Subject: **NOISE IN PICTURE**

Model: **BVM-D14H1E, BVM-D14H1U,
 BVM-D14H5E, BVM-D14H5U**

Figure 1

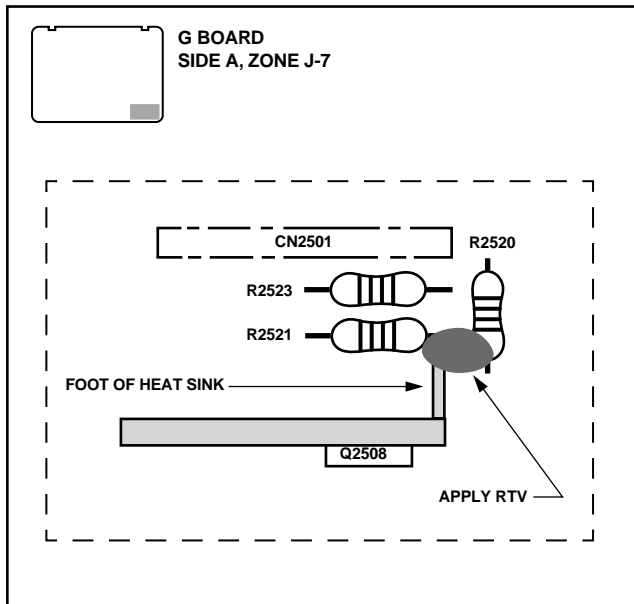
If the unit receives an excessive physical shock, R2521 on the G board may touch the Q2508 heat sink located nearby, resulting in noise in the picture.

1. Verify that R2521 sits straight up.
2. Apply RTV between R2521 and the heat sink.
